### ADDENDUM 1

## Austin Elementary School Heating & Air Condition (HVAC) Improvements Funded through the Elementary & Secondary Emergency Relief (ESSER) Funds May 31, 2022

## Addendum

**PROJECT** 218007.004 | Edinburg CISD - Stephen F. Austin ES - HVAC Improvements

**3** EXISTING A/C CLOSET - LOUVER INTAKE - ADMIN UNITS- DEMOLITION  
 MD3.02 1/2" = 1'-0"

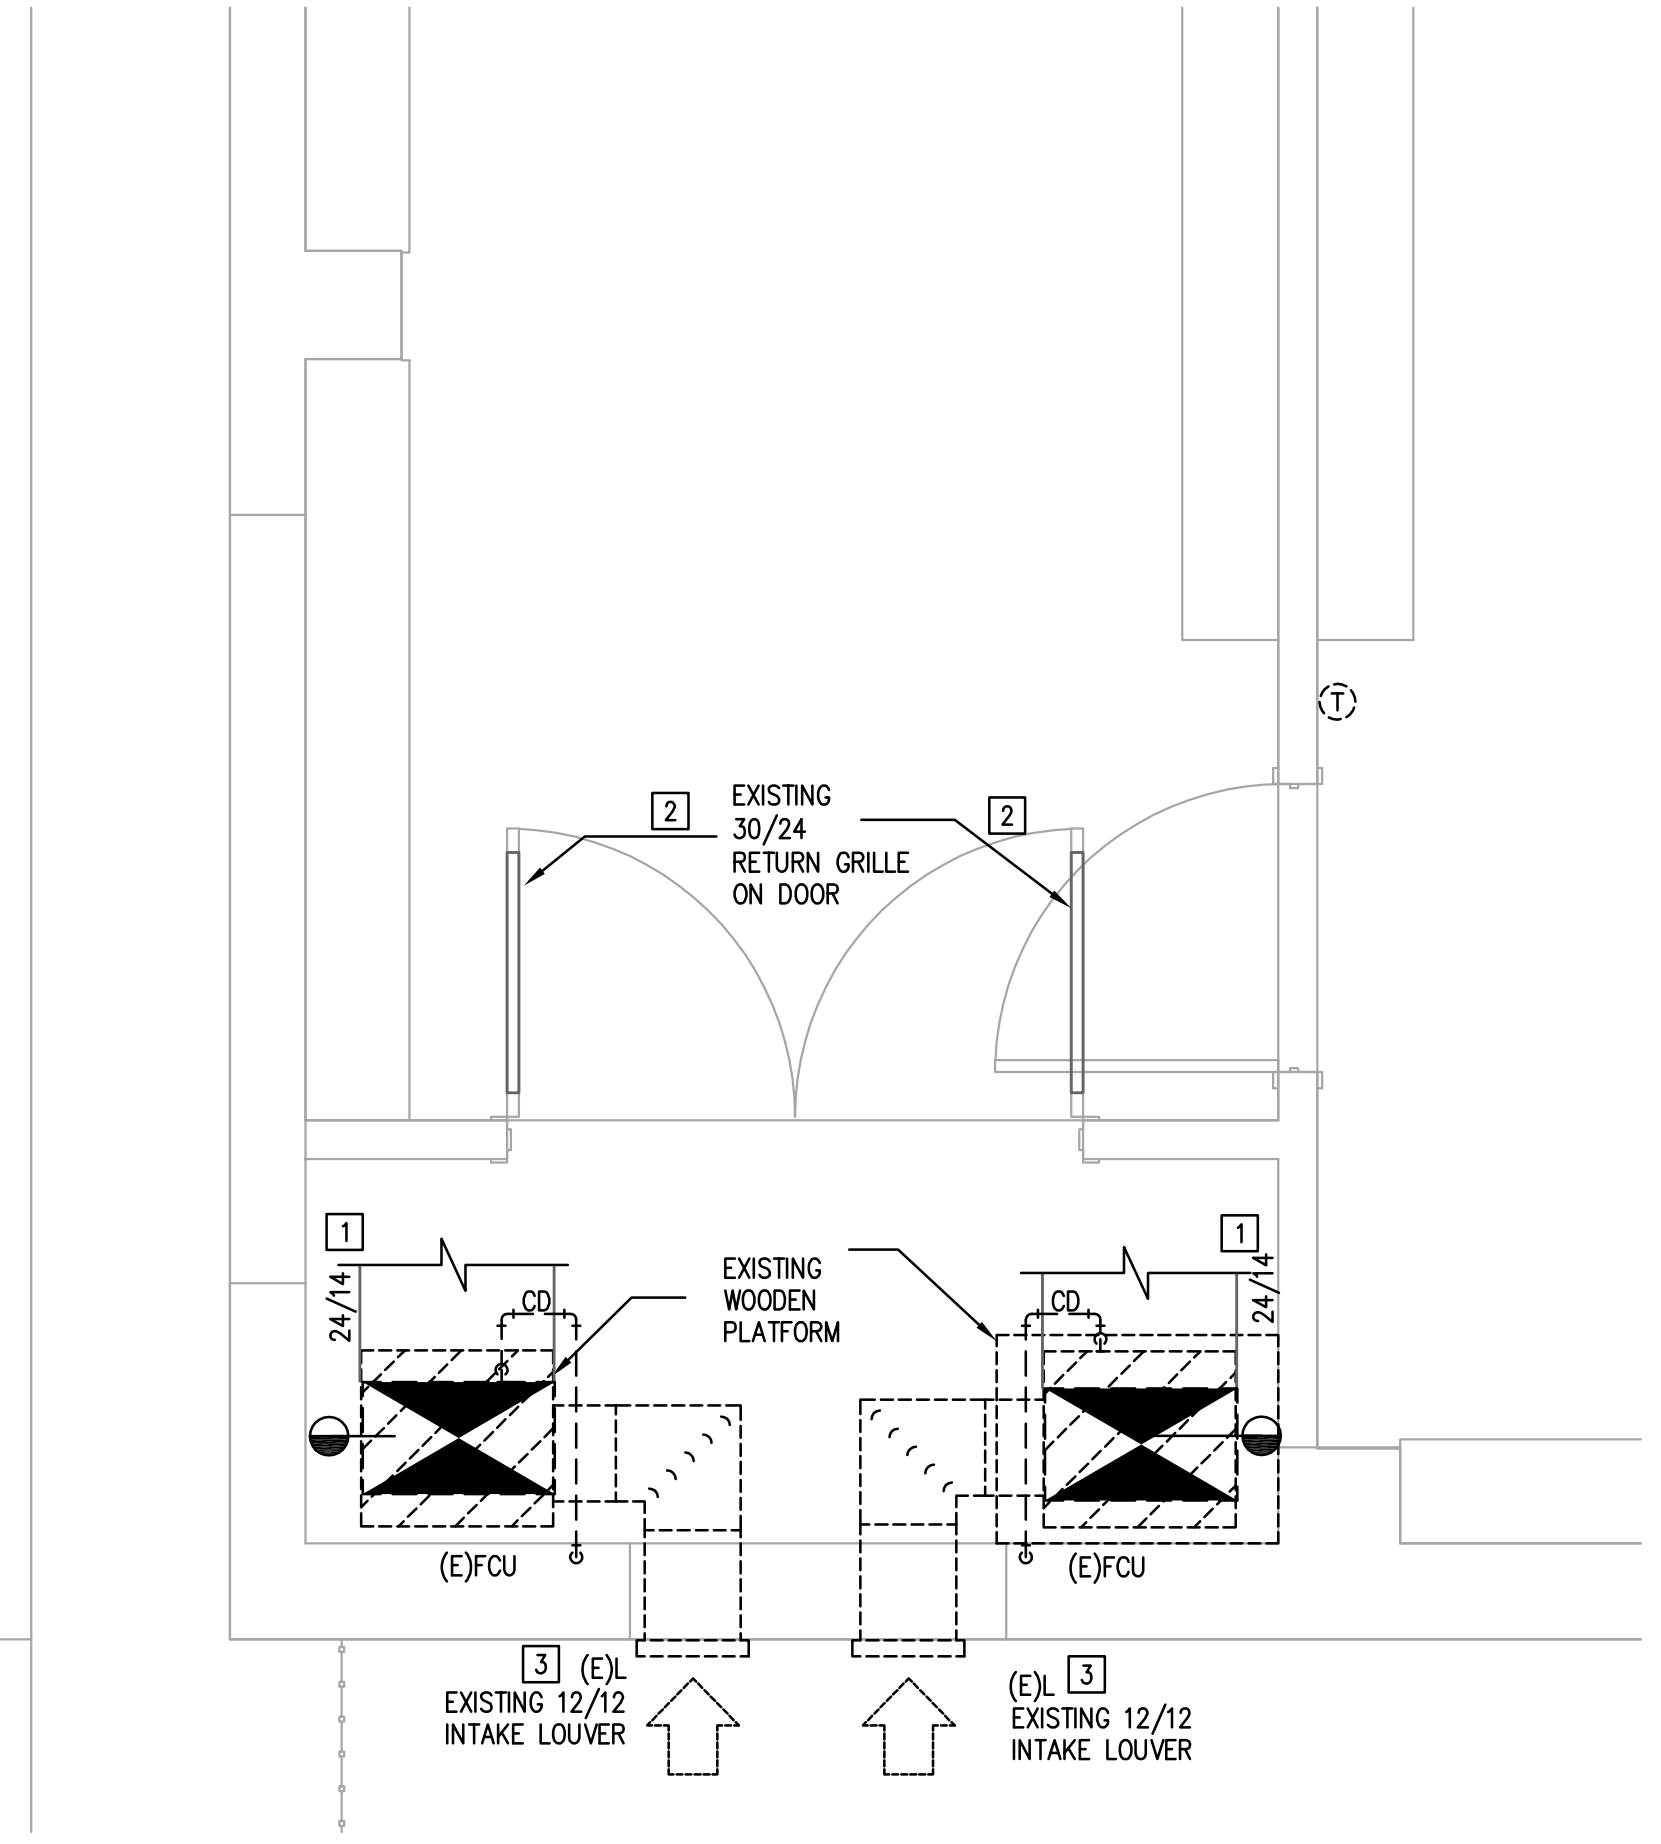
#### **Item 05 MD3.02 – Enlarged Mechanical Plans – Demolition**

- A. Revised keyed notes 1, 4, 5, 6.  
B. Added keyed note 2 to RA Grille in 3/MD3.02.
